Change Order Request

Williamson County Expo Center

Change Order Request: 014

Additional Scopes Via ASI ESI and RFI

210 CARLOS PARKER BOULEVARD TAYLOR, TEXAS 76574 SHT NO: XS-10
DATE: 07/12/16
BY: JS

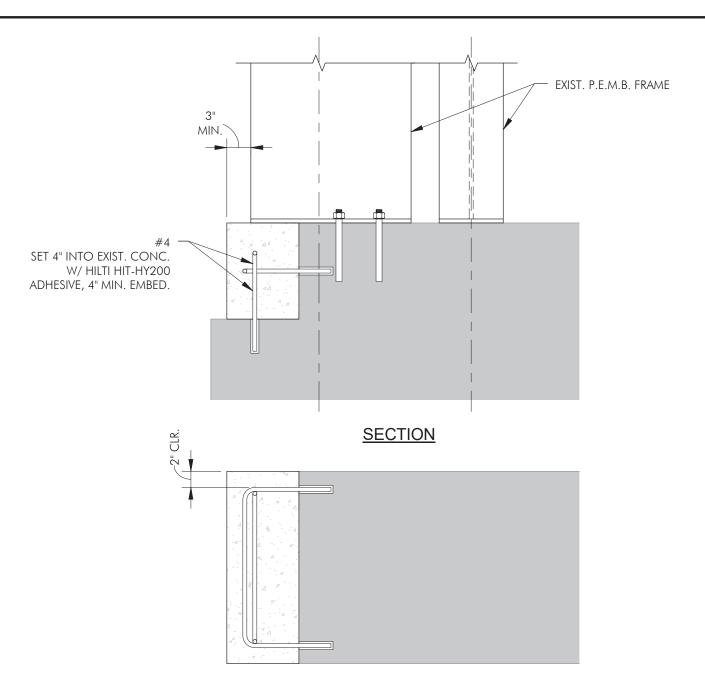
Extend footing pedestals to allow PEMB Portal Framing Column to have full bearing as shown on attached drawing.
